1202 Jefferson Avenue
Downers Grove, IL 60516
January 23, 2006

Cara Pavlicek, Manager
Village of Downers Grove
801 Burlington Avenue
Downers Grove, IL 60515

GREEN is Existing Conditions
RED overlay is Utility Plan

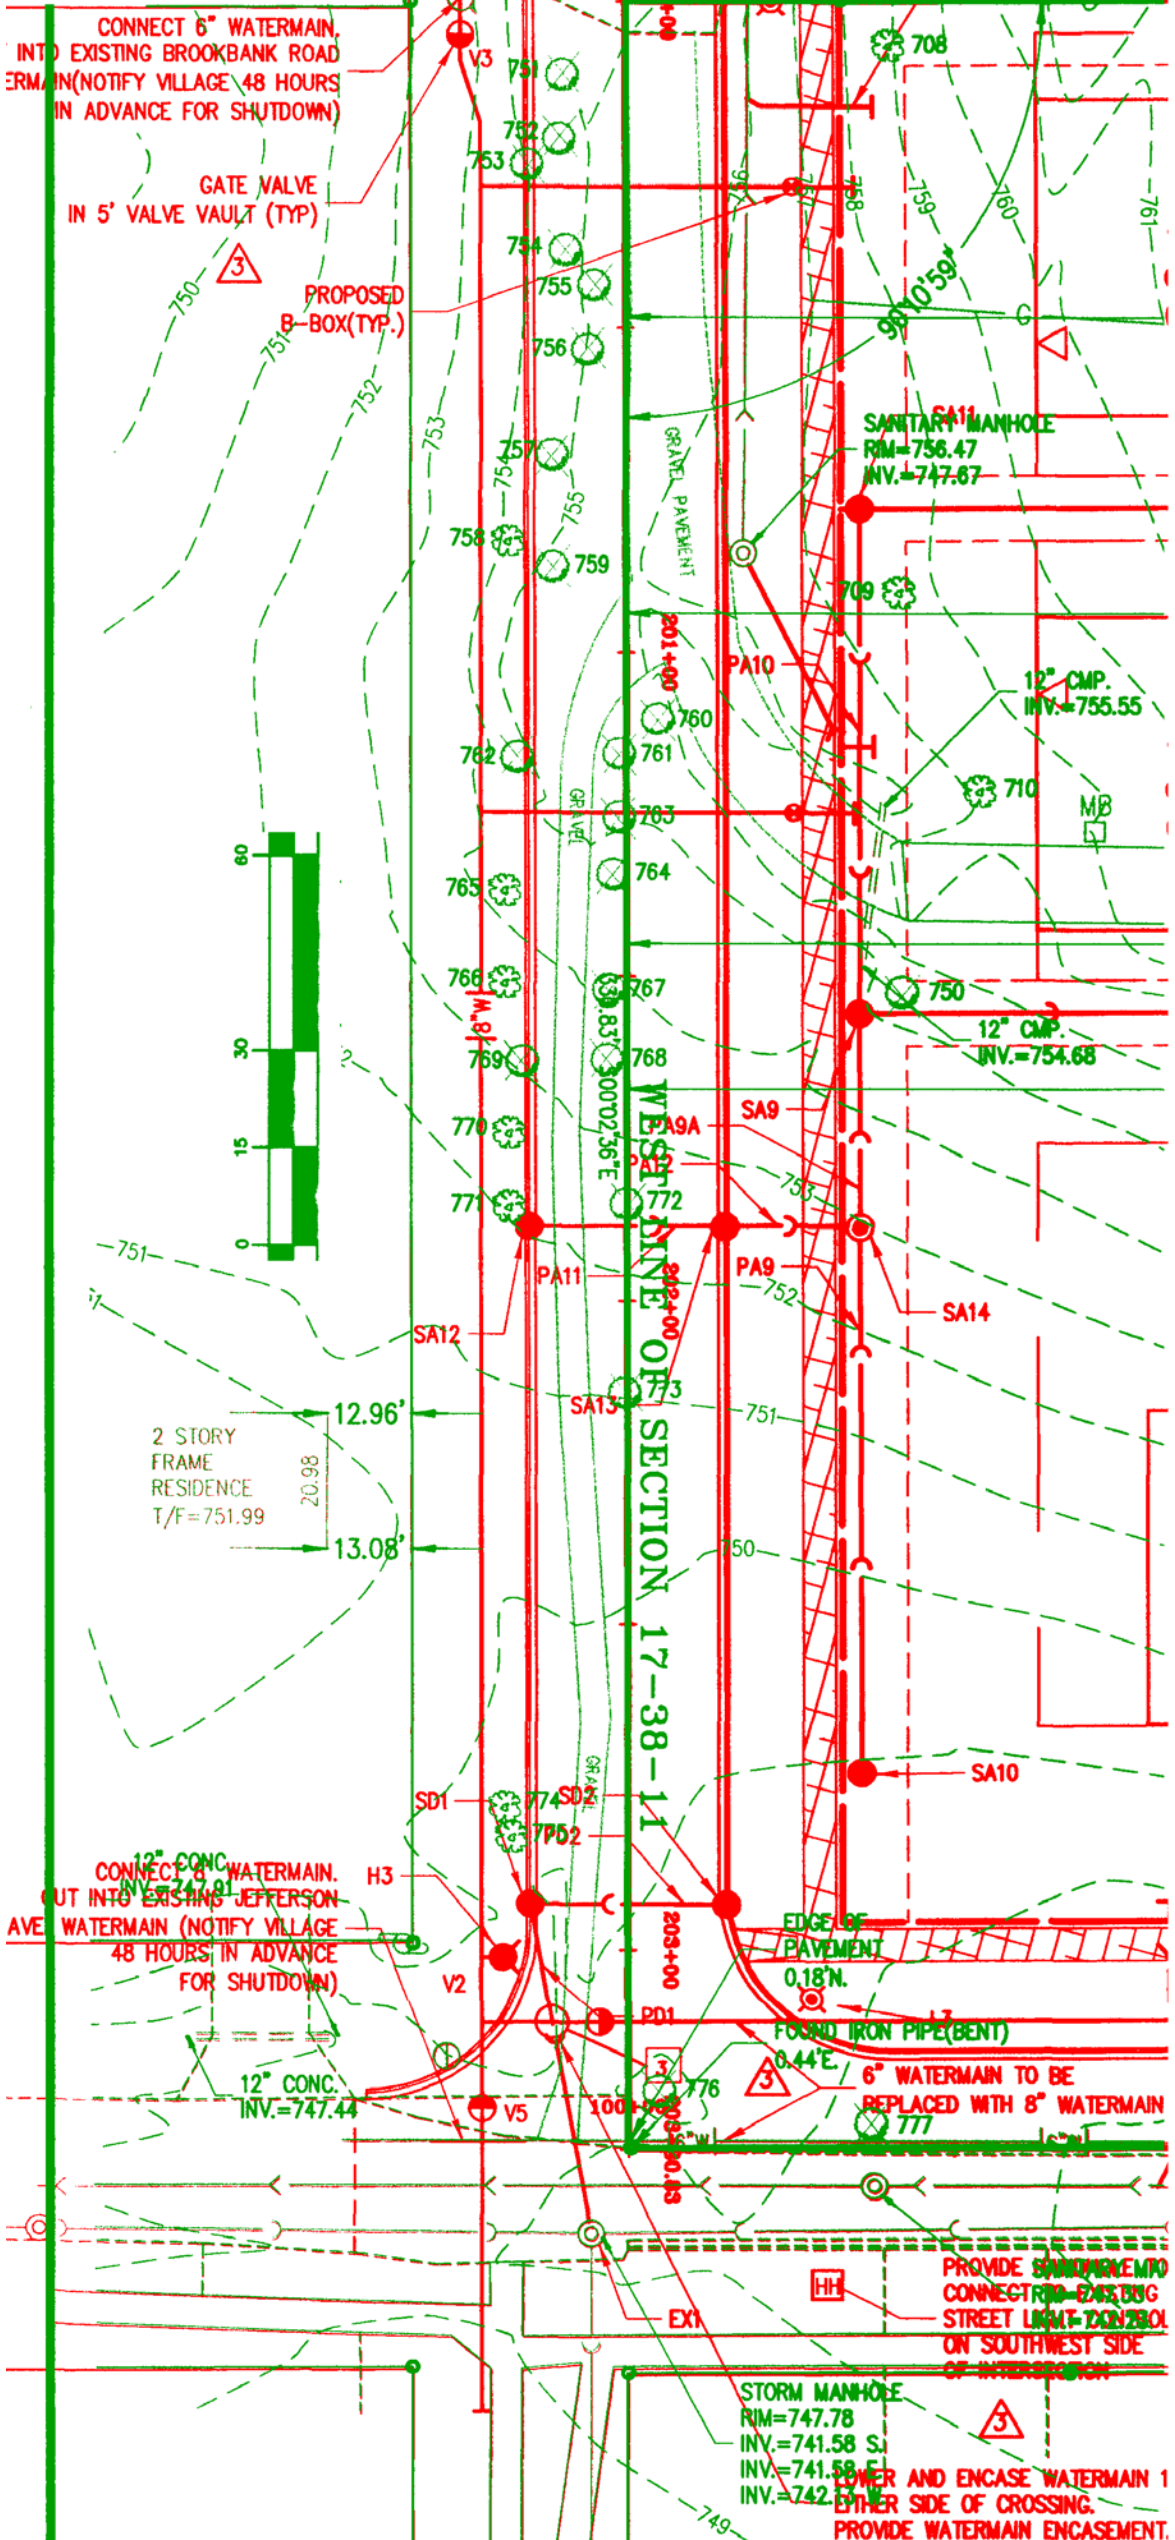
However recent plans show just the opposite result. The straight-through extension of Brookbank Road does the most tree damage, the north-south water main extension cuts off the western roots of the remaining trees, and the new culvert on the west curb inflicts even more harm to tree #771. It now appears that none of the trees will survive, including several not even listed on the developer's tree inventory.

Attached is a newly obtained diagram, in which the existing conditions are shown in green and the utility plan is overlaid in red, which demonstrates the impact. This is a new graphic not previously available to the Village.

We earnestly request that you and your staff reconsider the alternatives available to the Village, so that these trees and walking path can be preserved for the future.
